**Woodward 3rd Party Review –
Constructability and Construction
Phasing Review**

City of Hamilton

Stantec Consulting Ltd. was retained by the City of Hamilton (City) to conduct a 3rd party review of the proposed Phase 2 upgrades at the Woodward WTP. Recently, the City has undertaken a number of studies related to the Phase 2 upgrades project.

Figure 2-2: Summary of Existing Construction Schedule

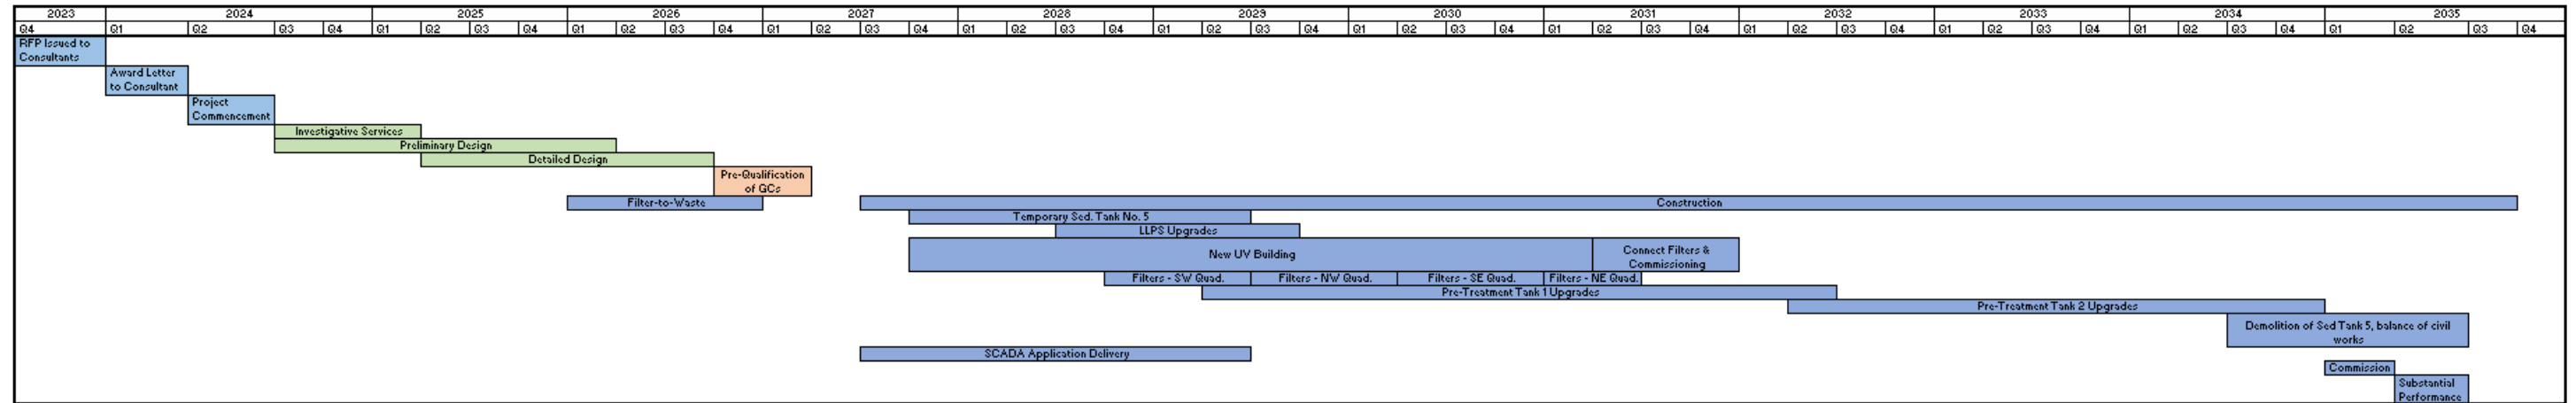
A high-level summary of the existing schedule as presented in the AECOM CDR is presented in Figure 2-2. Significant overlapping works are likely to increase complexity of construction and increase constructability risks.

The proposed construction schedule (**Figure 2-2**) requires the plant to operate in an off-normal flow configuration, resulting in higher than typical flowrates expected in portions of the plant. Stantec has identified two hydraulic increase cases that we recommend be investigated for the presence of bottle necks and mitigation methods elucidated before construction starts.

Figure 3-1: Possible Optimized Phase 2 Construction Schedule

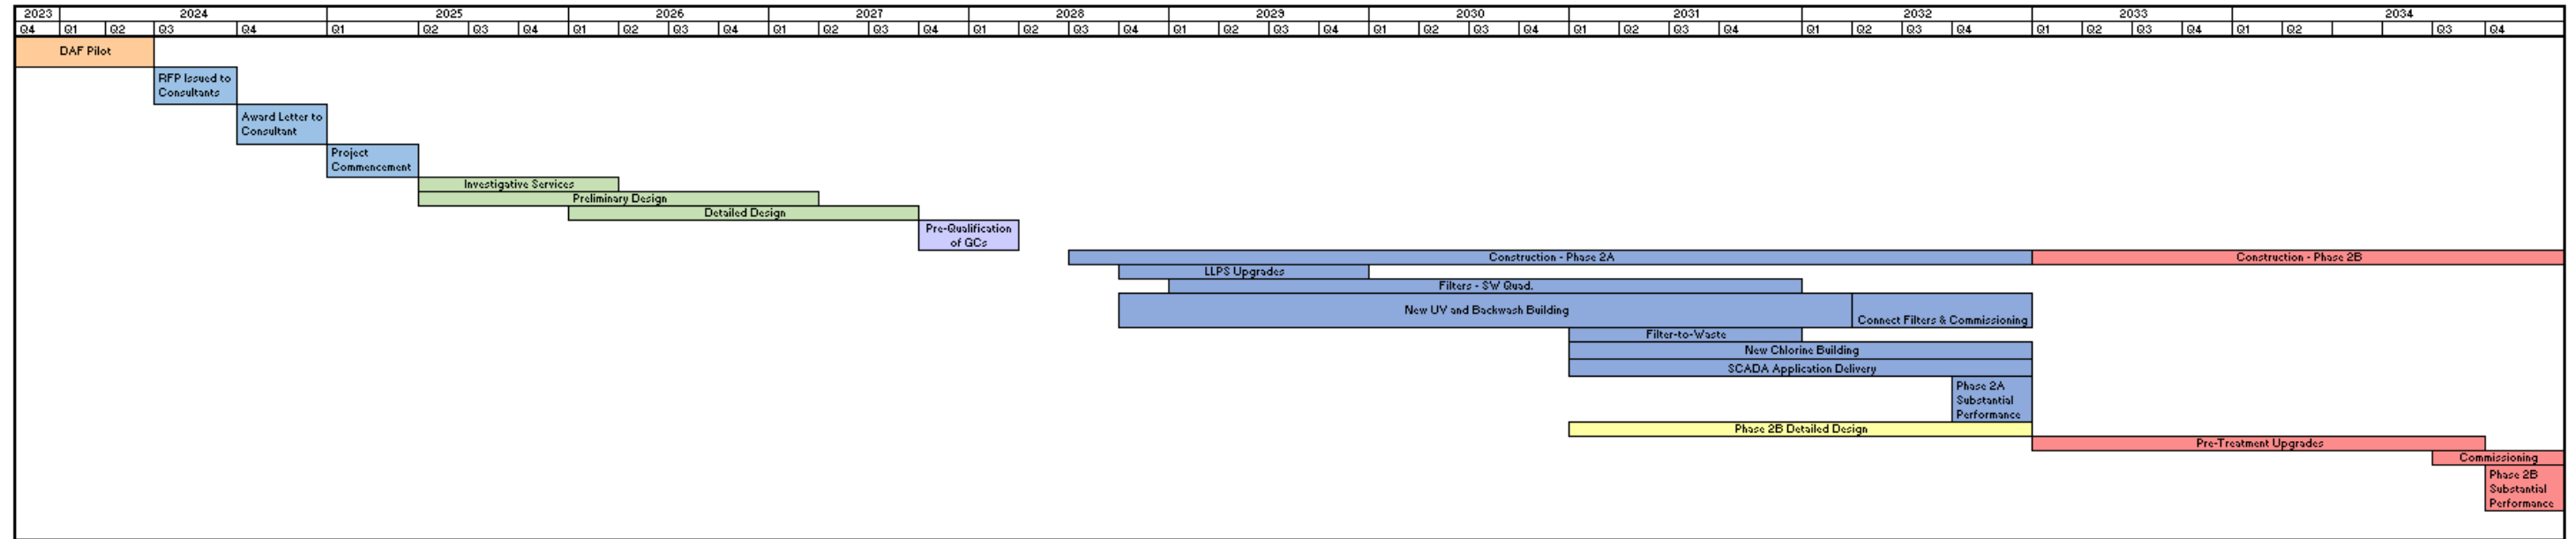
Modifying the phasing plan and completing pre-treatment upgrades after disinfection and filtration upgrades will allow more time for selection of the preferred sedimentation technology. It is critical to select the preferred pre-treatment technology and develop a feasible conceptual design prior to initiating detailed design in order to allow for accurate cost estimates, detailed proposal submissions, and selection of an appropriate experienced design firm. The existing design for enhanced sedimentation upgrades with plate settlers requires complex and substantial construction, costs, and staging for a technology that may not be the best fit for this facility and budget. A possible optimized schedule for the Phase 2 Upgrades is shown in **Figure 3-1**.

Figure 4-1: Proposed UV Building Infrastructure and Layout (Source: AECOM Conceptual Design, 2021)

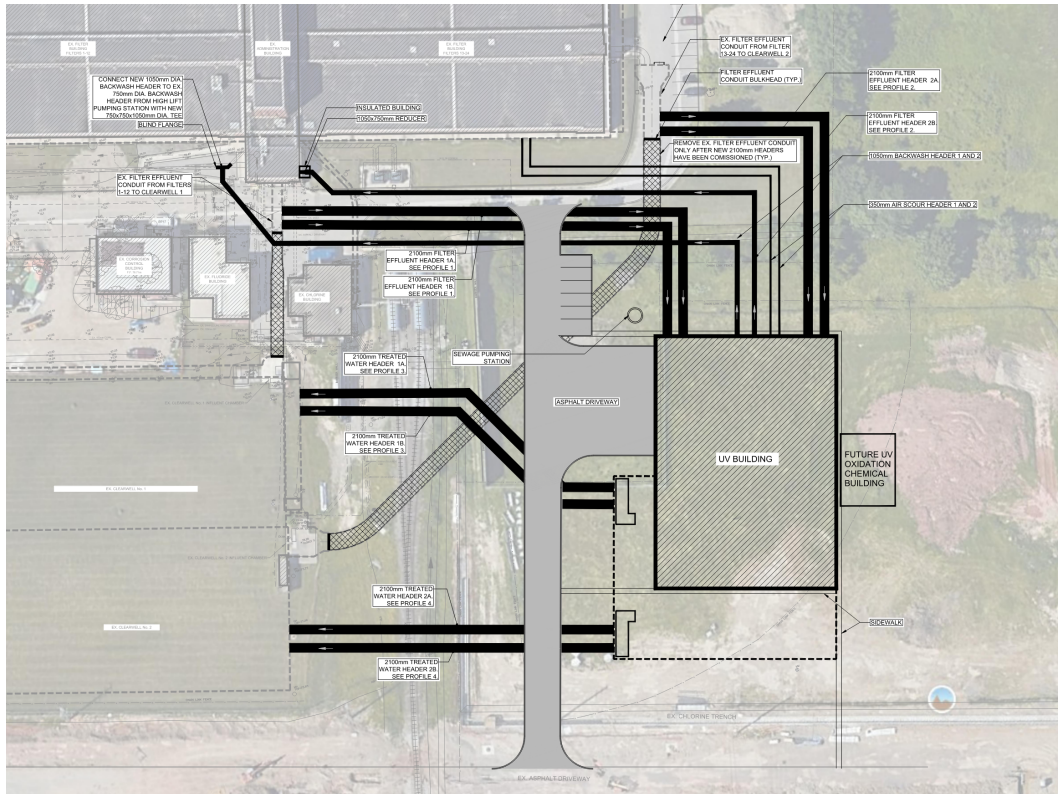
The below image (**Figure 4-1**) is the UV Building in the proposed location complete with all major new infrastructure connecting it to the existing treatment train. At first glance, the piping arrangement appears to be convoluted, where portions can be deleted in full, and others simplified. It is worthwhile clarifying that we have assumed that all major pipe systems have been twinned to eliminate single points of failure concerns the City might have within the treatment process.

A main concern with the piping system as shown is the concept shows 2100 mm diameter pipes connected to existing conduits where the condition of this conduit is unrealized until fully excavated and inspected during construction, posing risk that the exterior concrete may require additional structural restoration efforts. Additionally, connecting 2100 mm diameter pipes as shown, presumably CPP, would require significant downtime to the existing system, further complicating the running of the plant during construction.

The UV outlet at the southerly portion of the building connecting to existing Clearwell No. 2 results in an unnecessarily long downtime to Clearwell No. 2. The City has already completed modifications that permit flow into either clearwell through one common influent channel. It should be noted that based on the current CT calculator, the City does not count CT provided through the clearwells, therefore without clearwell 2 in operation, there is no impact to plant capacity.

After having reviewed the site piping layout, we believe replacing the pipe system with a cast-in-place (CIP) concrete split conduit would better serve the City by minimizing the amount of downtime required for connections.

Figure 4-2: Alternative Conduit Connections (Drawing Source: AECOM Conceptual Design, 2021)

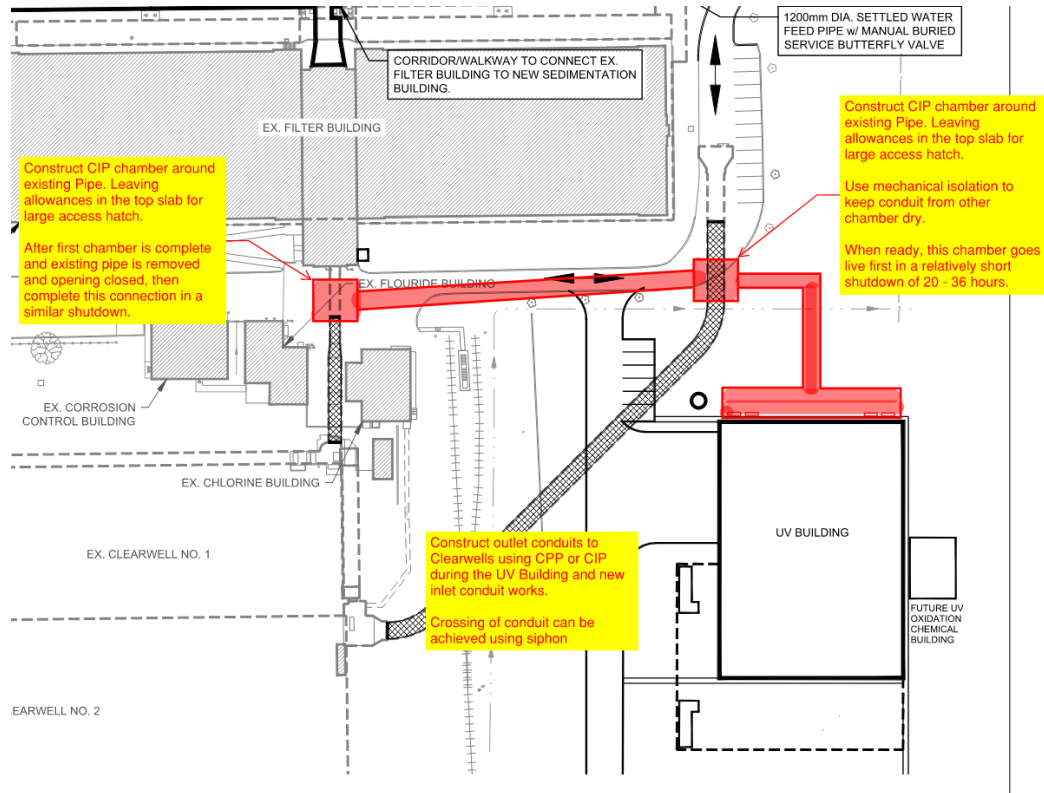
Flexibility could also be realized when connecting to the existing conduit systems by first constructing a CIP chamber around the existing conduits whilst they remain in service, uninterrupted by the construction process as shown in **Figure 4-2** below. This would allow all final connections to be made and backfilled before the system is connected live.

Within the connecting chambers, the use of slide gates or large diameter valves on pipe embeds would permit the selection of one or both conduits to be in service.

The final connection would be a simple short duration shut down to remove a section of existing conduit, making the system live. This is a critical part of the project and careful consideration should be given to the ease of removal of these existing conduits during detailed design. Room for wire saws, and concrete removal should be considered to keep the overall tie-in between 20 and 36 hours of downtime.

Figure 4-3: Proposed Sedimentation Tank Structural Works (Source: AECOM Conceptual Design, 2021)

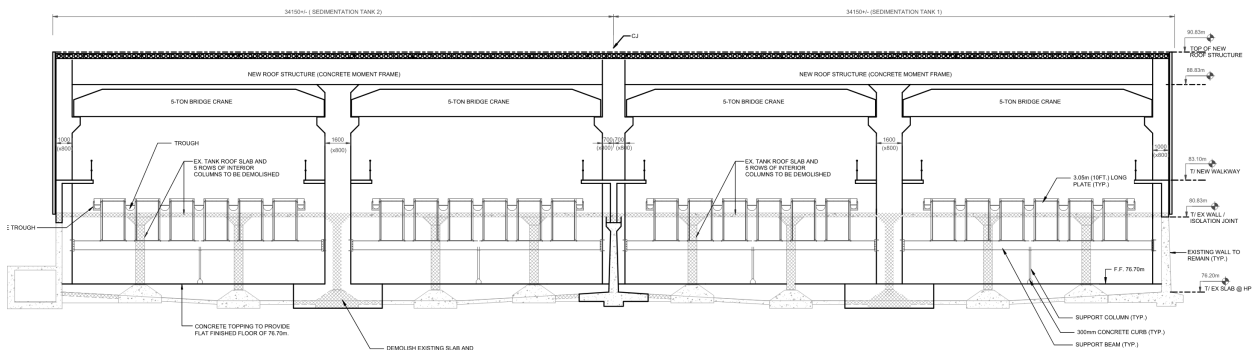
The conceptual plans indicate that Sedimentation Tanks 1 and 2 will undergo significant structural modifications that will expose all stakeholders to an equal amount of unforeseen risk. This will also result in an extended downtime of both tanks at the same time to complete the works as shown.

Consideration should be given to an alternate construction method that does not require such invasive structural modifications. It is our understanding from discussion with the Woodward WTP staff that the maximum allowable interruption to the Sedimentation Tanks 1 & 2 would be one out of service at any one time. As shown now, the center wall isolating Tanks 1 & 2 requires full roof removal, wall extension upwards, and new roof sections constructed before one of these two tanks could see temporary service.

The level of effort getting one tank back into service is likely to exceed one year of construction where two tanks would be out of service, assuming no unforeseen issues arise during construction. It should be noted there are many unknowns that will have to be fully investigated before a construction schedule could be produced. These unknown items include but are not limited to: existing concrete condition, existing soil bearing capacity to withstand the additional pressure of a raised tank and water volume weight, and the existing water table depth and fluctuations as this design shows many large penetrations through the tank floors to construct large concrete column supports. The Stantec team understands the City has retained a consultant to complete this review.

Figure 4-3 provides a visual of the large slab penetrations, raised walls, and new roof construction in the current conceptual design.

Further design related discussions are recommended with this task to ensure the City can accommodate calculated interruptions to more appropriate portion of this facility.

Figure 4-5: FTW Piping Conceptual Design (Source: CH2M Filter-to-Waste report, 2021)

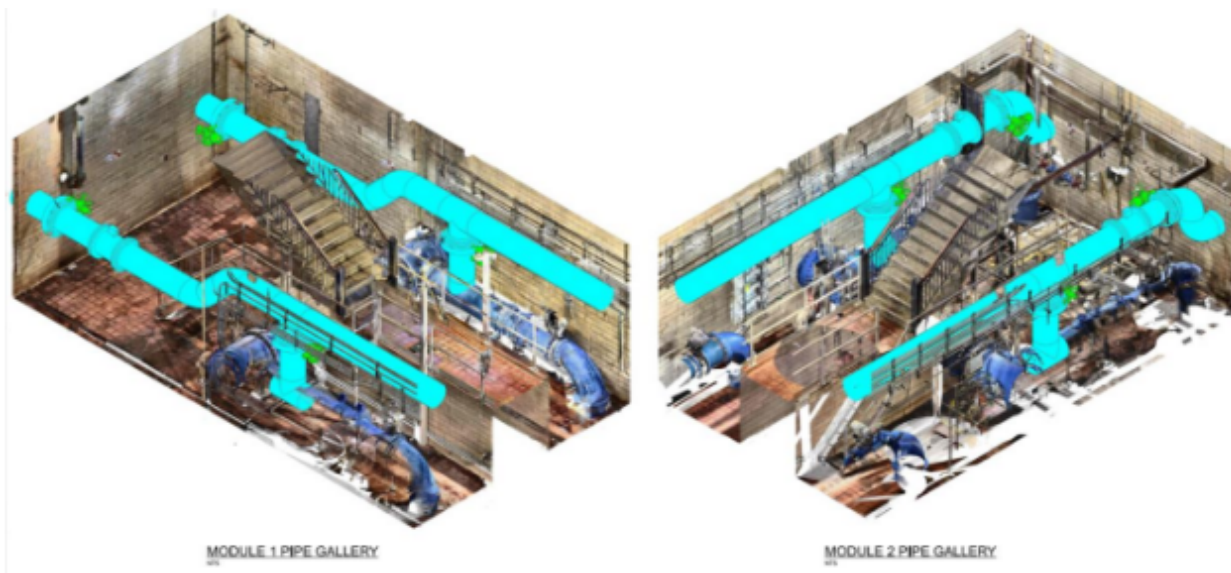
There are concerns regarding how this piping would integrate into this area of the plant that is already a very old build and having its own degradation issues. During our November 18, 2022 site visit, there were signs of water weeping up through the floor tiles, hollow sounding floor tiles indicating issues below, concrete spalling, and reinforcing steel corrosion.

At face value, integrating the FTW piping within this pipe gallery may appear to be the easiest way to implement the system, but it will not be without careful staging within a congested area as shown in the photo in **Figure 4-6**.

Critical Tie-Ins

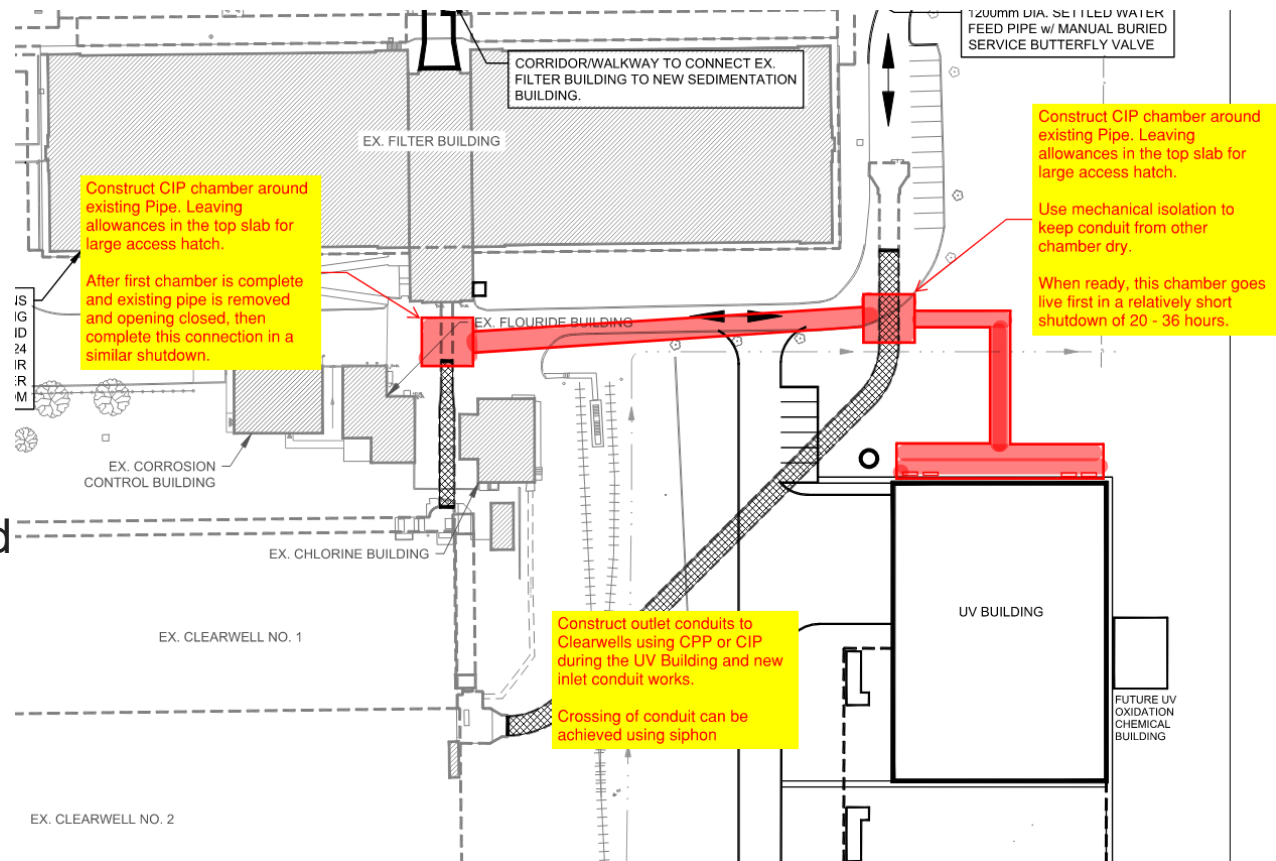
- Duplicate large pipes
- Difficult possibly custom connections to existing conduits
- Connections require longer shut down of clearwells

- Is there an Owner driven requirement to have two flow conduits from each tie-in location versus one at each?
 - Confirmation of this helps steer the direction the City will be required to build
 - Specifically, if possible, is there a rule of no single point of failure stipulated?
 - One CIP conduit is more suited to this project
- One CIP conduit is easier to construct than large diameter
- Consider using CIP structures at connection points

Proposed Conceptual Design

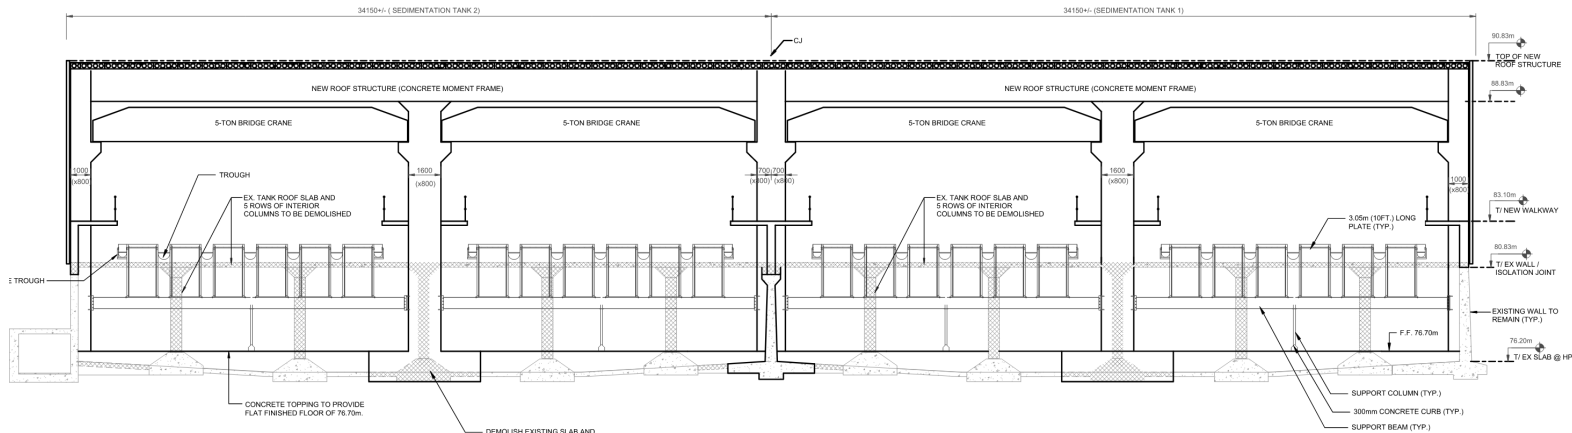
Extensive works shown here raising some questions that should be considered

- Can two sed tanks be down this length of time? Must be to complete works as shown.
- If empty, is hydraulic uplift a concern due to groundwater?
- Is structure capable of supporting new loads?
- Is existing soil condition capable of supporting new loads?
- Access limitations require use of one or more likely two tower cranes. Using RT or Mobile cranes is expensive and possibly not possible to complete all areas of work. Plan on having two dedicated locations for Towers.
